CITY PLAN COMMISSION STAFF REPORT

Cookingham Development – Expansion

CD-CPC-2025-00024
Rezoning without Plan
CD-CPC-2025-00025
Area Plan Amendment
CD-CPC-2025-00026
Development Plan – Non-Residential

Case Number: CD-CPC-2025-00026

EXISTING TYPICAL RIGHT-OF-WAY SOUTH SECTION - NW COOKINGHAM DRIVE
SCALE: 1" = 5'-0"

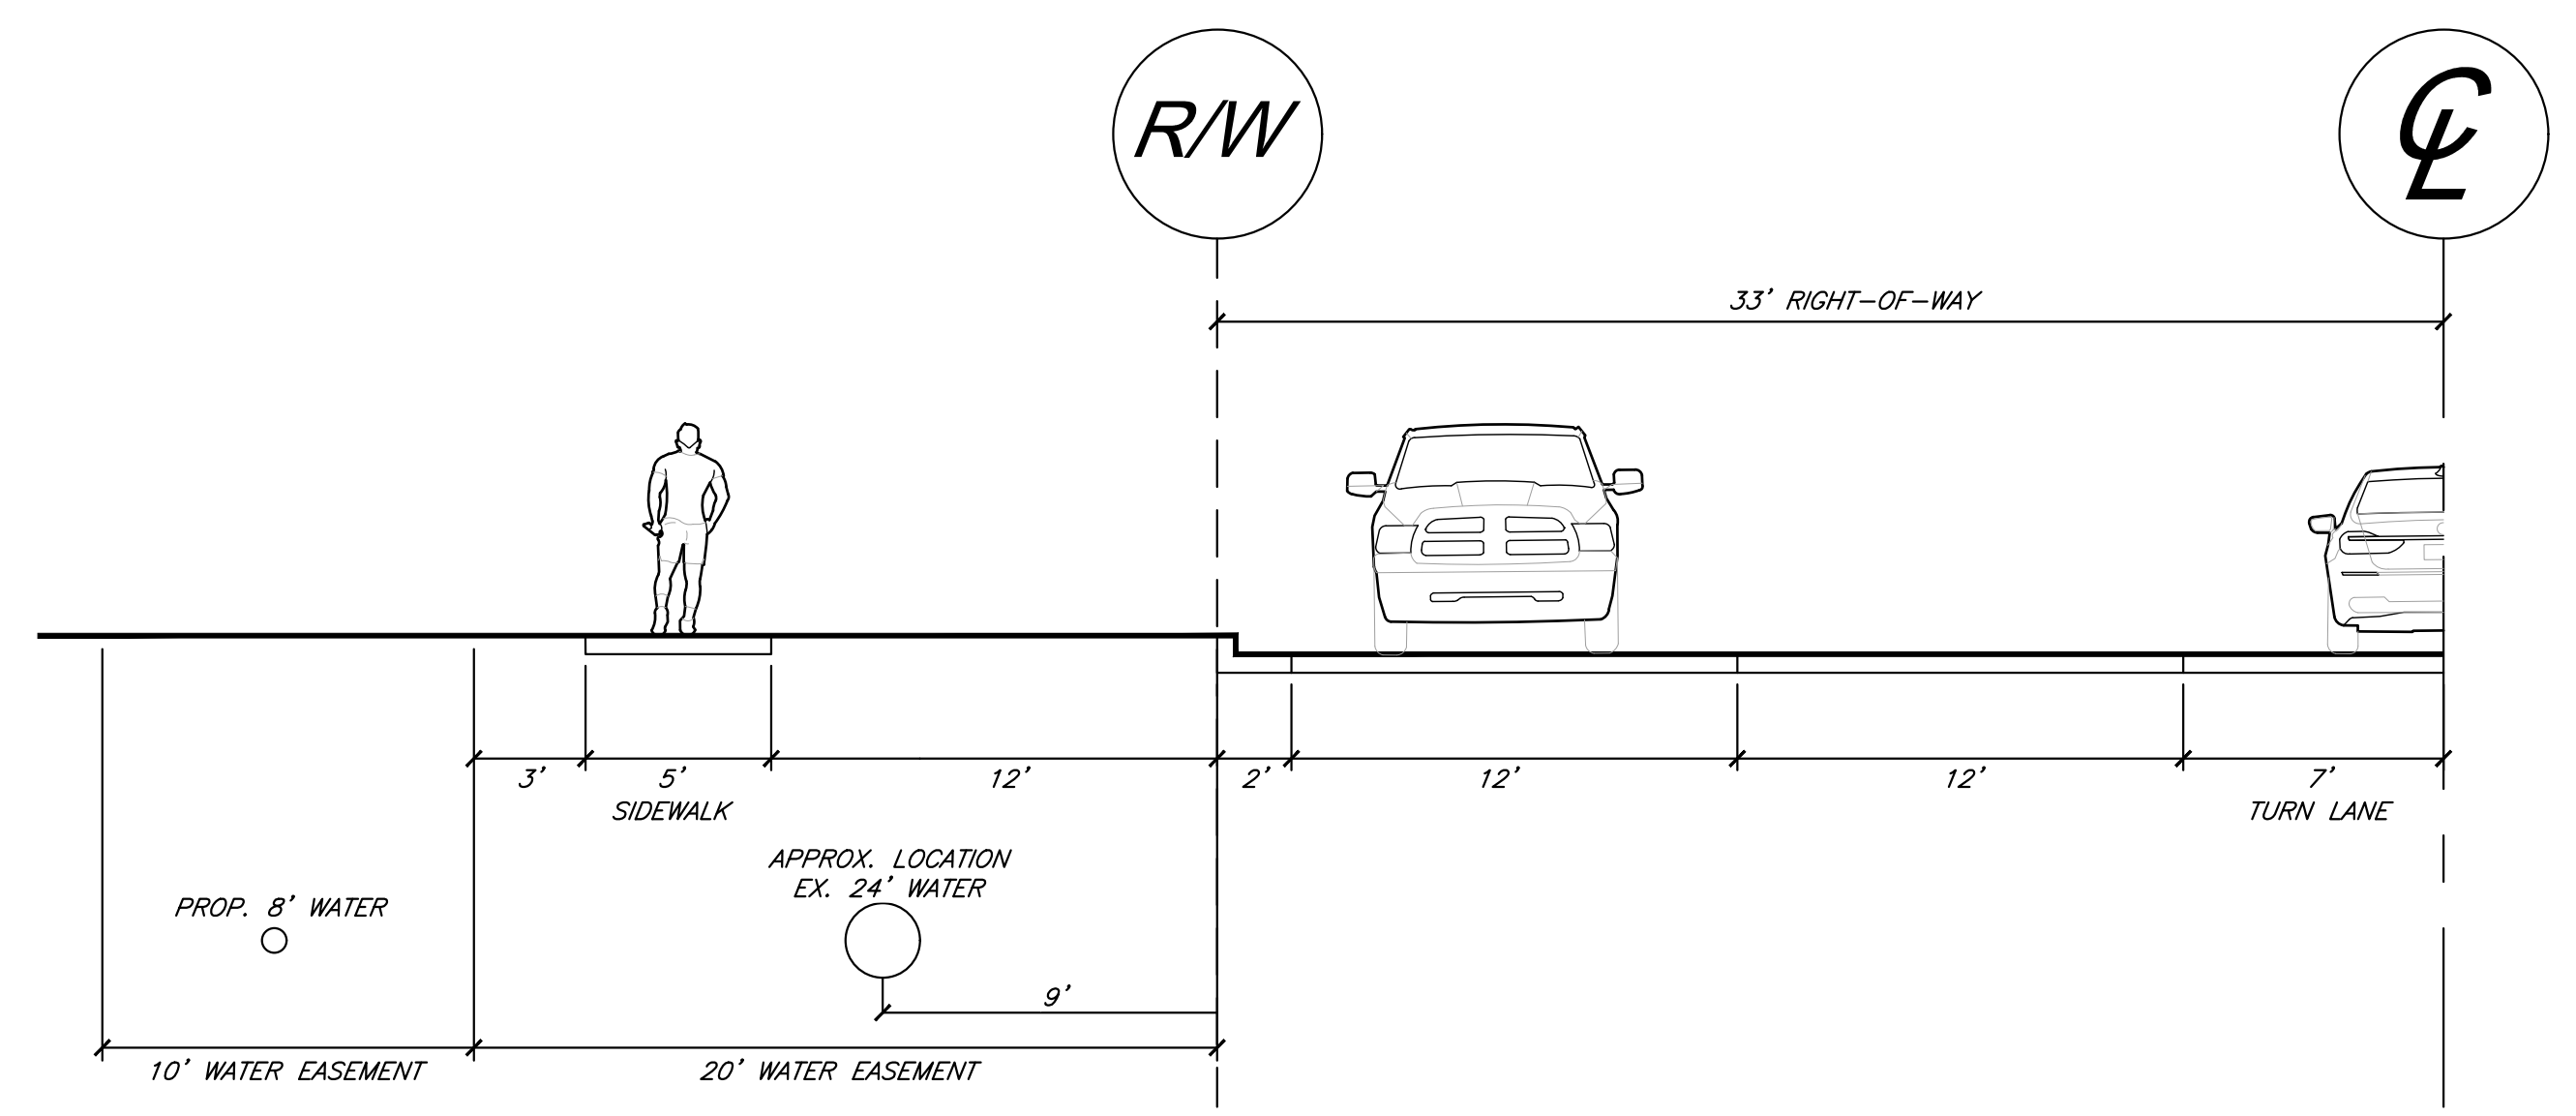
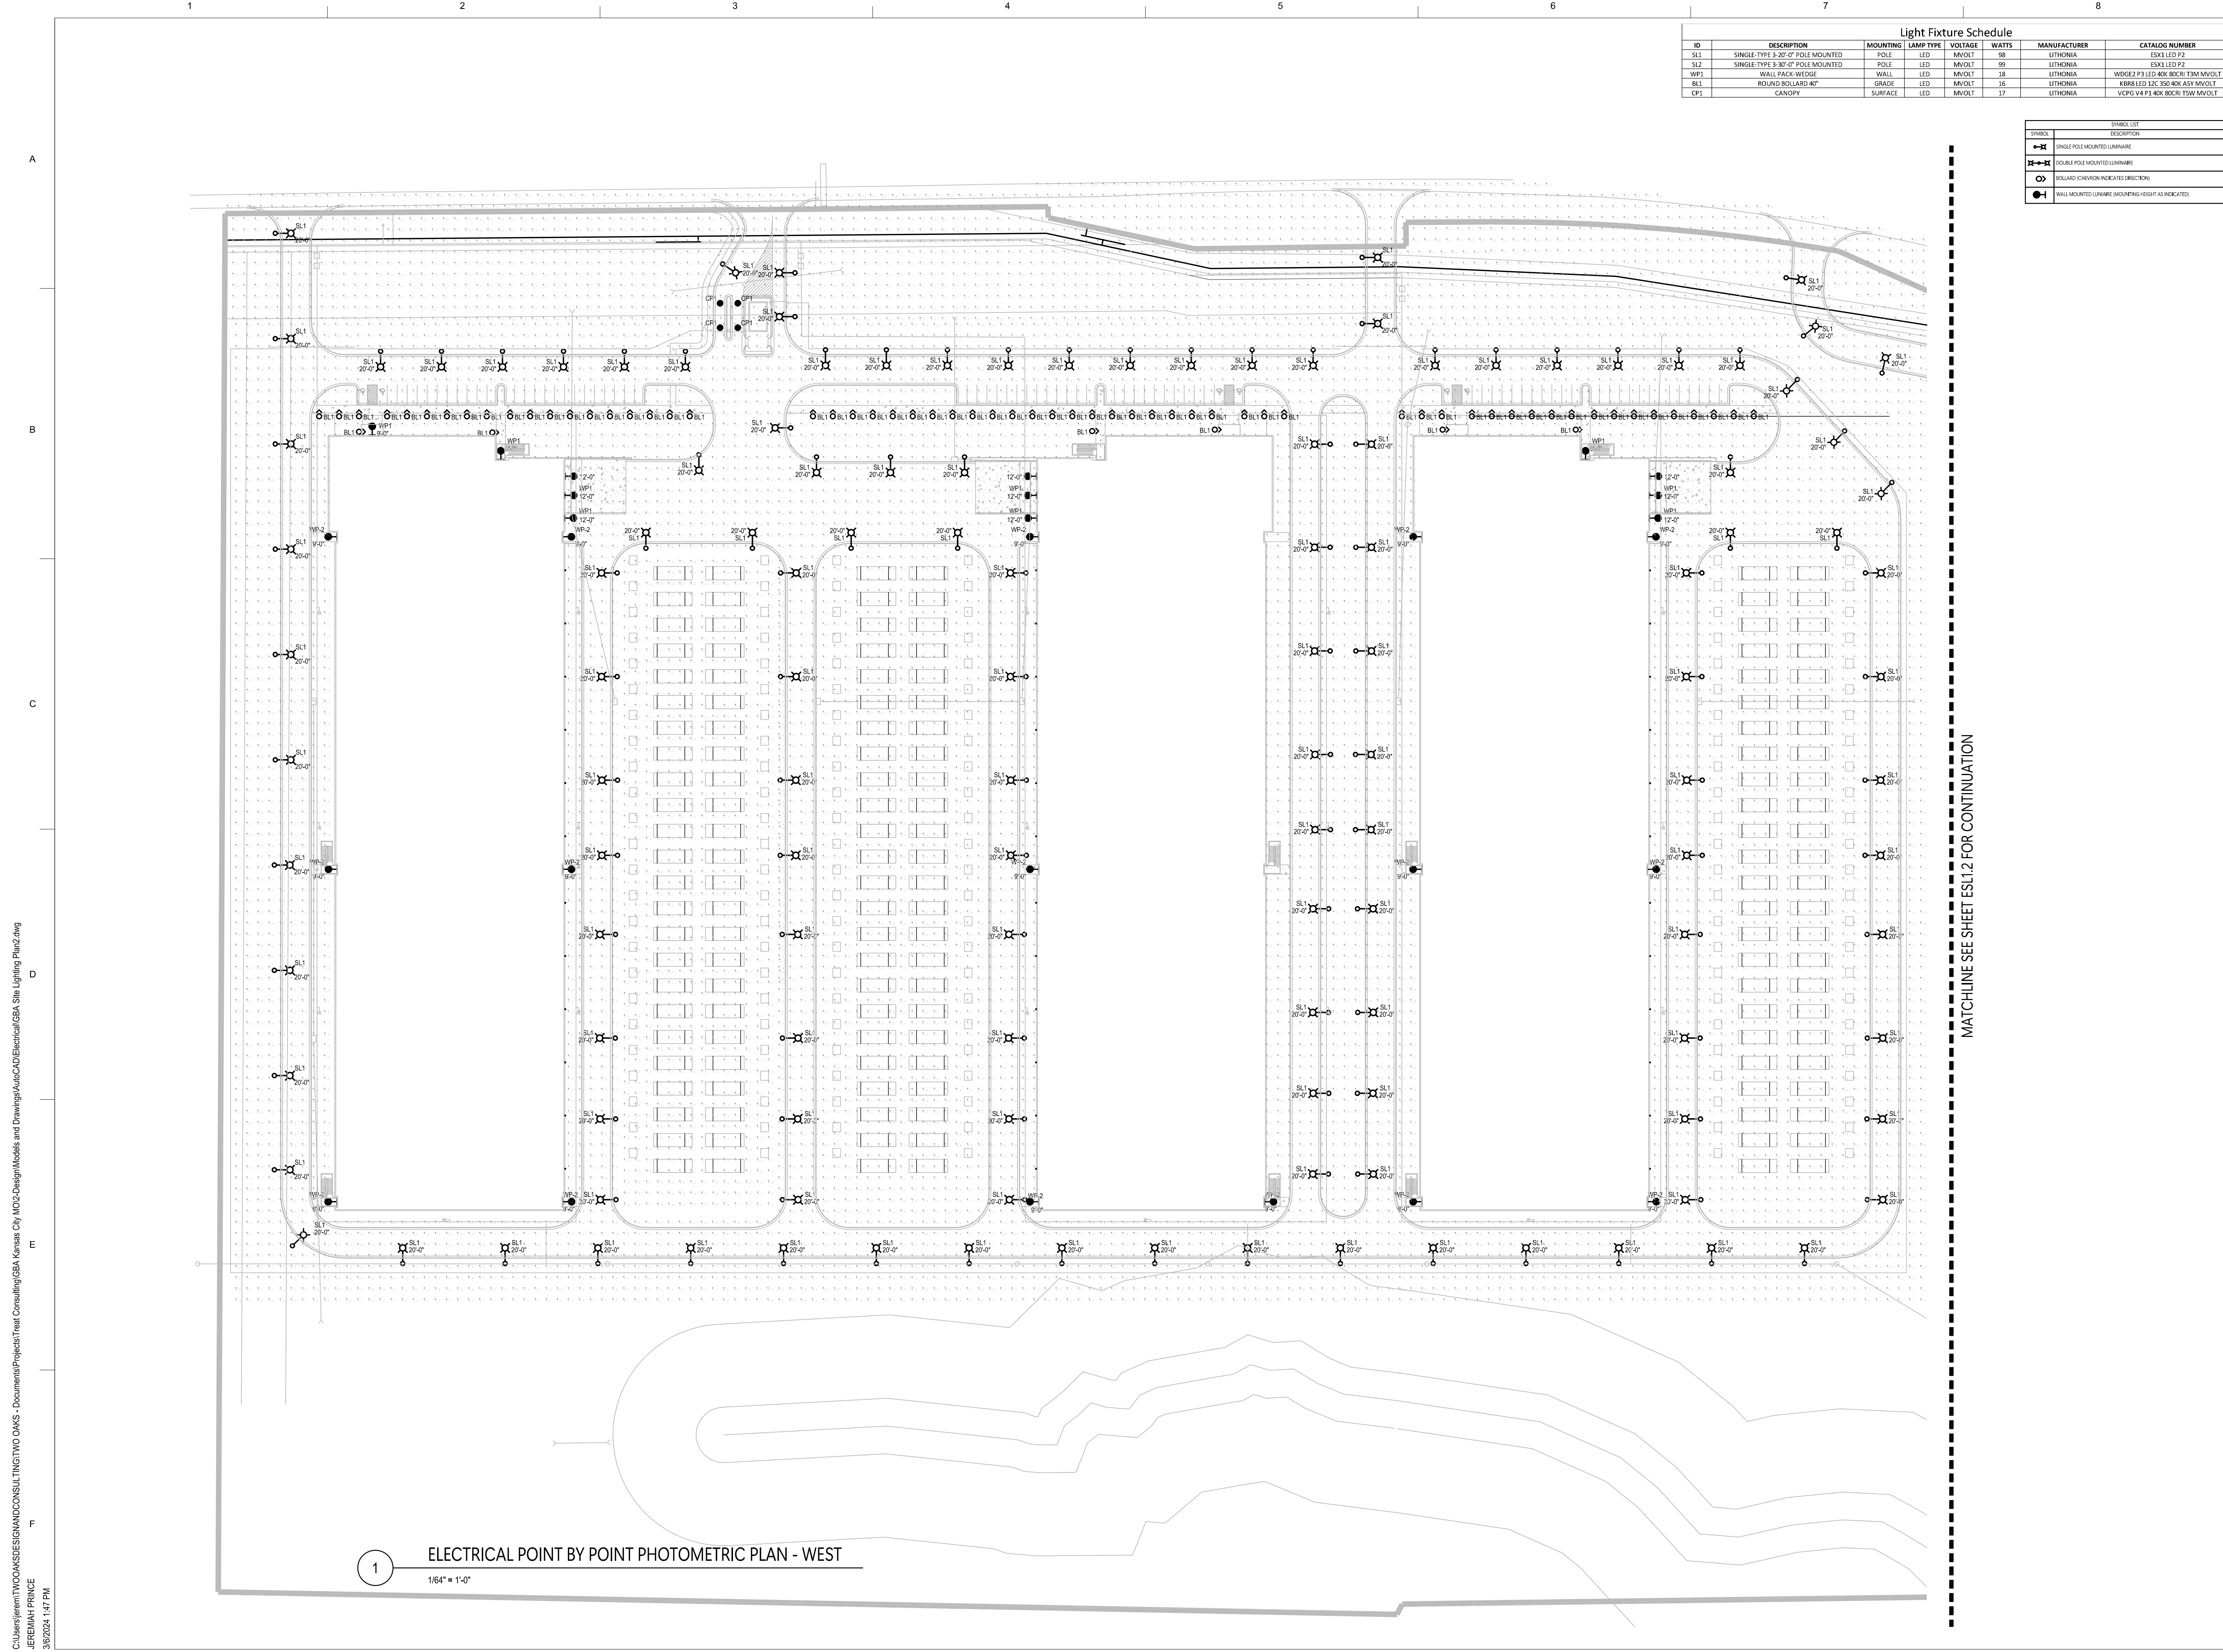
KC Water and the Public Works department have asked the applicant shall confirm that they are providing the correct amount of right-of-way to allow for future improvements to NW Cookingham Drive.

7. The developer shall dedicate additional right of way [and provide easements] for NW Cookingham Drive as required by the adopted [Major Street Plan and/or Chapter 88] so as to provide a minimum of 60 feet of right of way as measured from the centerline, along those areas being platted.
